Replacement Cross Reference

This magnetic switch replaces the models shown in the left hand column. Non "PH" models (e.g. 307, 307CD, 274, etc.) are discontinued and are replaced by the new models shown in this Cross Reference. Note the mounting differences between old "PH" and old "non-PH" models. All new models have the same mounting as the old "PH" models. A mounting template is included

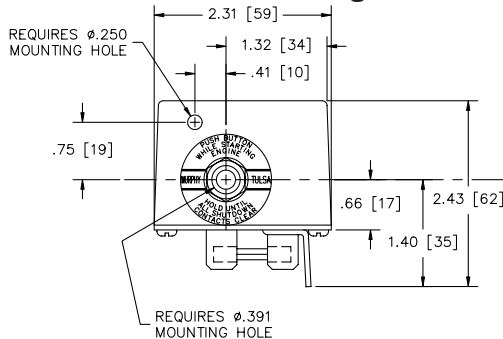
in the unit carton for the new model. Otherwise, operation is the same for old and new models. Terminal crossover letters/numbers are shown for each model. Note in some cases terminal(s) are not used with the new model. Also note that a jumper (provided in the hardware package) may also be required.

| Discontinued | Terminal Crossover | | Replacement |
|--------------|--|-----------------------|--|
| | 221PH E C B D S | Changes to | MS2110 1 2 3 4 5 <p>To Alarm To IGN. or Fuel Valve Terminal #6 not used. Jumper #2 & #4</p> |
| | 169PH G C S B | Changes to | MS2110 6 1 3 4 <p>TR7207 Jumper #2 & #5</p> |
| | 274 274PH C S B | Changes to | MS2110 1 4 3 <p>Energize to Stop* Terminal #6 not used. Jumper #2 & #5 *Customer supplied disconnect switch.</p> |
